## ADDENDUM No. 2

RFP No. 23-25

### Earhart Road Improvements Project

DRAWING No. 2021023-55

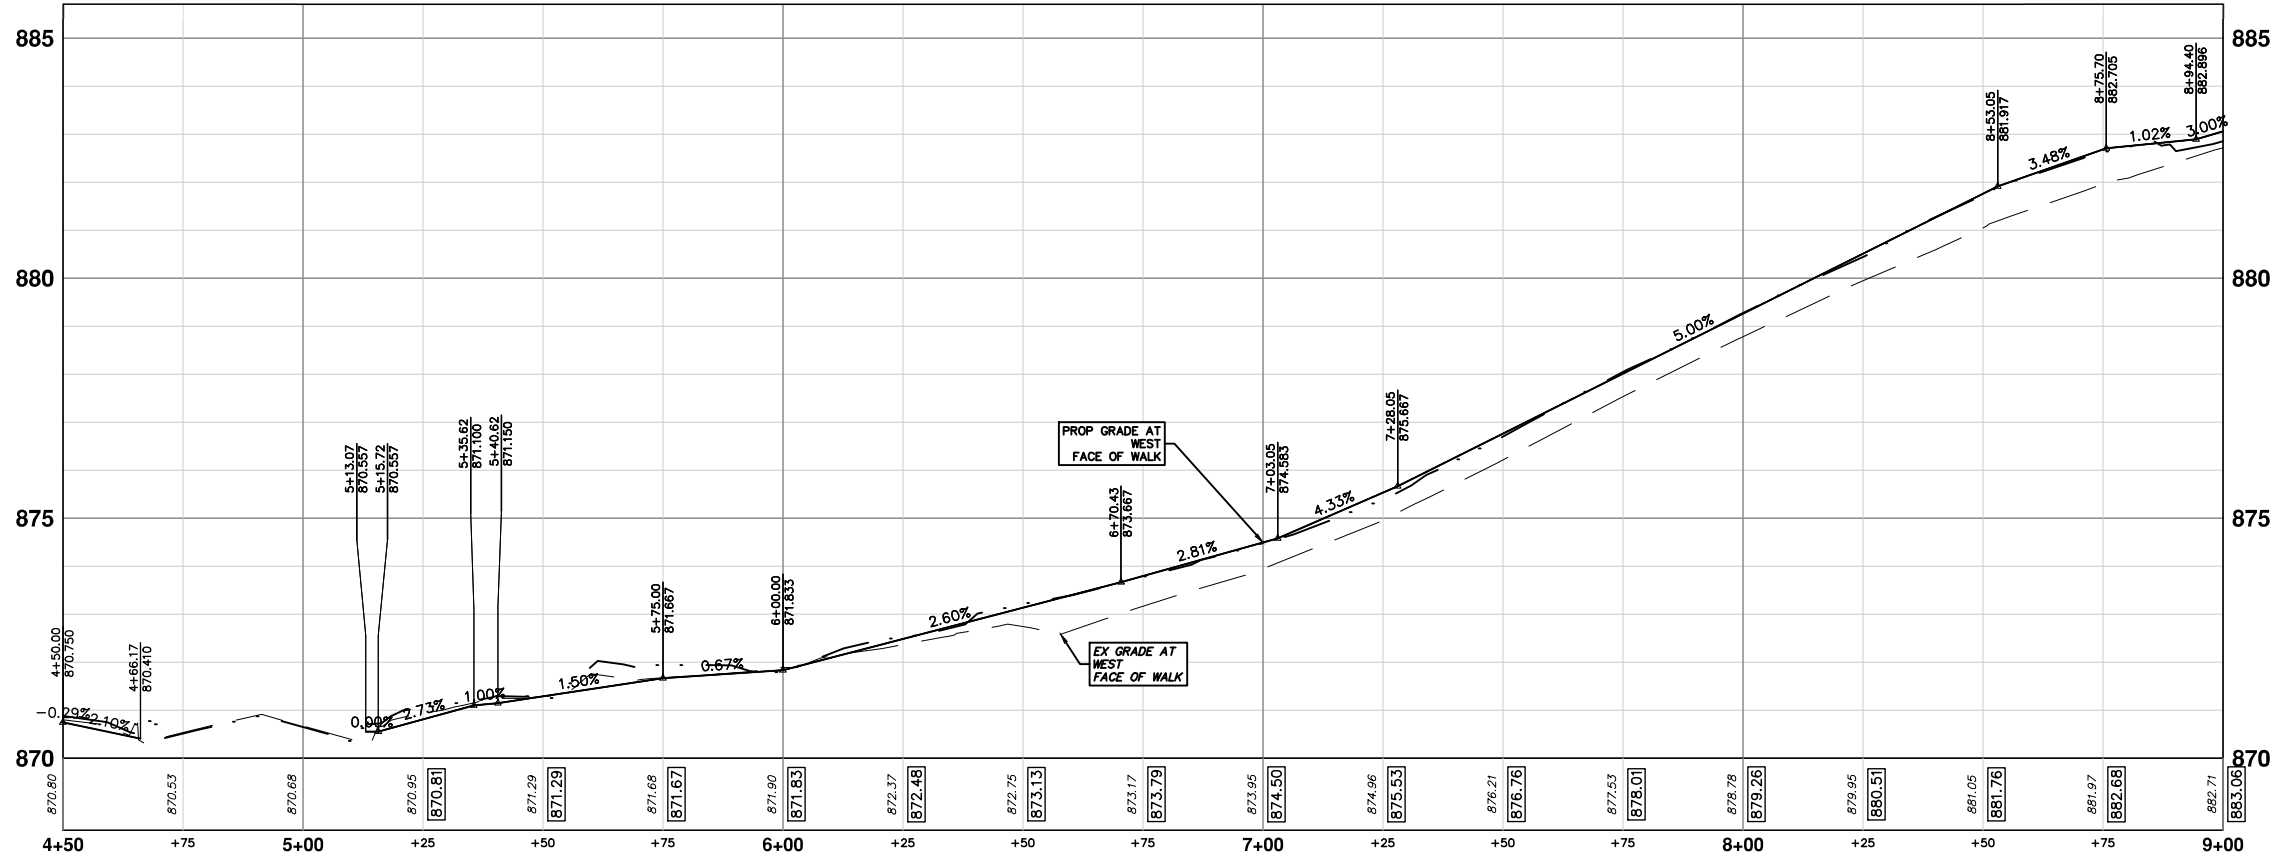
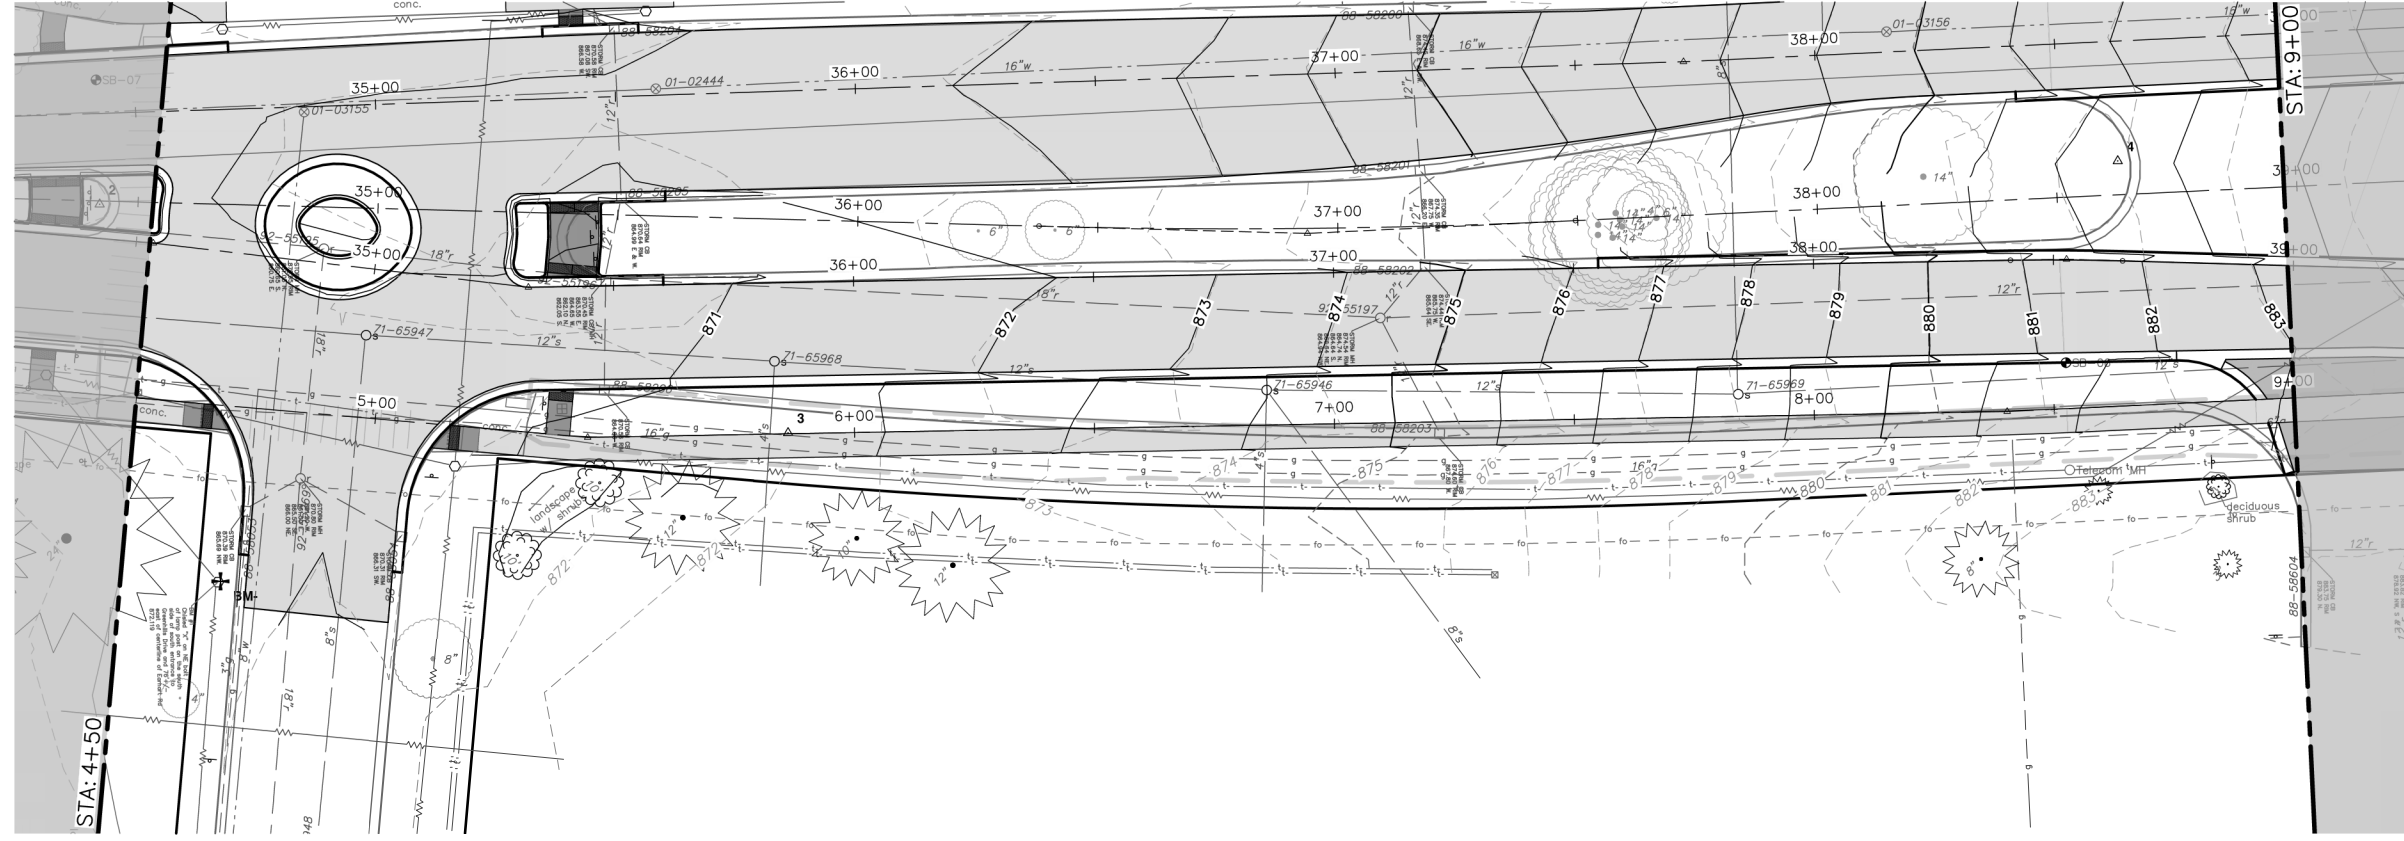
New Plan Sheets 46-50	Include plan and profile of new curb line along lane narrowing.
New Plan Sheets 55-59	Include plan and profile sheets for new sidewalk.
Plan Sheets 61-63	Revised to include Detail Grades
Plan Sheets 66-74	Revised pavement marking plans to reflect use of Cold Plastic Bike Symbols and arrows.
Plan Sheet 75	Revised cross sections to include sidewalk retaining wall.
Replace Plans Sheets 1-85	Entire plan set is re-issued as addendum.
Wage Decisions Pg 6-7	Heavy MI 20230074 02/03/2023 and Highway MI 20230001 03/17/2023 wage decisions in effect for the project as references documents can be downloaded from Sam.Gov
Bid Form Replace Pages 15-18 with pages 15-18	The bid form has been amended to reflect the modifications of this Addendum No. 2 and other quantity corrections from original contract documents.
Replace Pages DS-1-2	Detail Spec Index, Replace to include new items
Replace Pages DS-26-27	Conduit, Direction Bore
